[Docket No. FAA-2009-1088; Directorate Identifier 2008-SW-76-AD; Amendment 39-17872; AD 2014-12-11]

Airworthiness Directives; Sikorsky Aircraft Corporation Helicopters

ACTION: Final rule.

2014–12–11 Sikorsky Aircraft Corporation:
Amendment 39–17872; Docket No. FAA–2009–1088; Directorate Identifier 2008–SW–76–AD.

Figure 1 to Paragraph (e)(3)(iii)

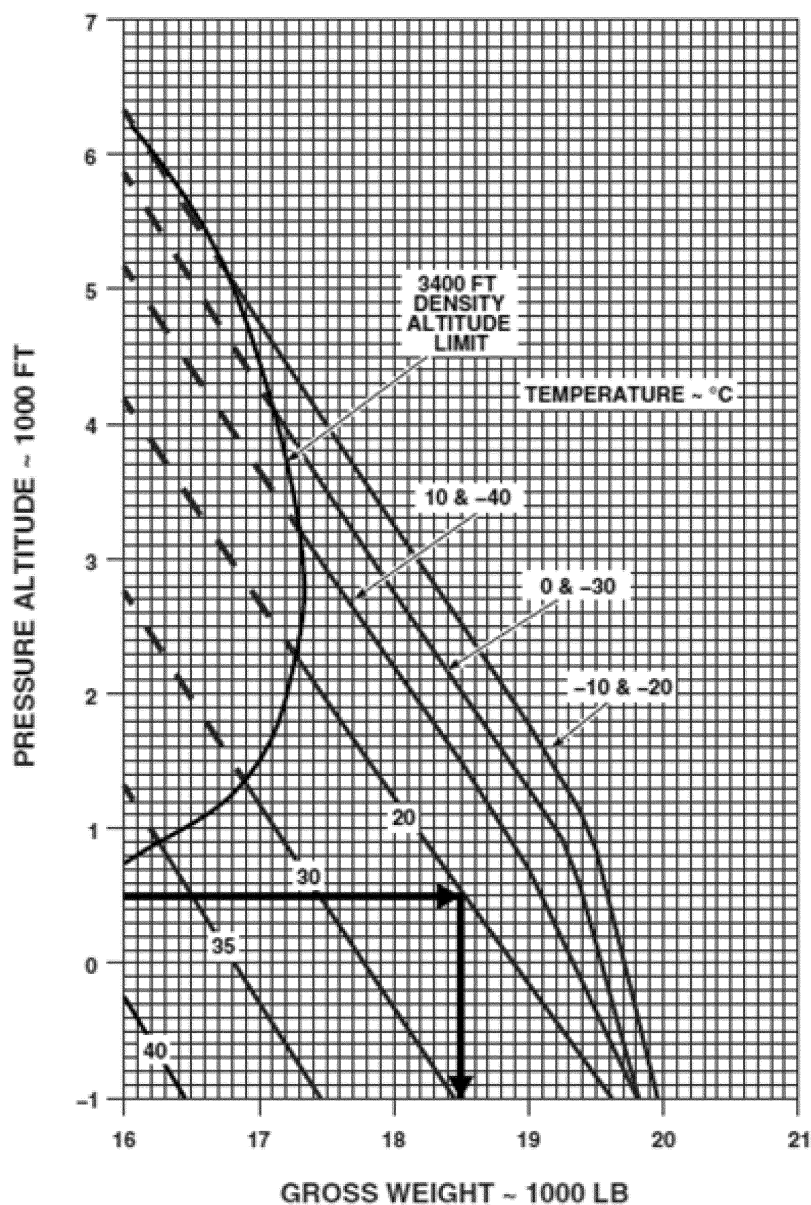
(iii) Add the following and insert Figure 1 to Paragraph (e)(3)(iii) of this AD: “HOIST” Maximum gross weight for Human External Cargo, which requires category ‘A’ performance capabilities, is limited to the gross weight determined in accordance with the following Figure 1 to Paragraph (e)(3)(iii) of this AD for your altitude and temperature with the air-conditioner, anti-ice, and bleed air turned off.

Note 1 to paragraph (e)(3)(iii) of this AD: Figure 1 to Paragraph (e)(3)(iii) of this AD becomes Figure 1–2A when inserted in the “Weight Limits” section of your RFM.
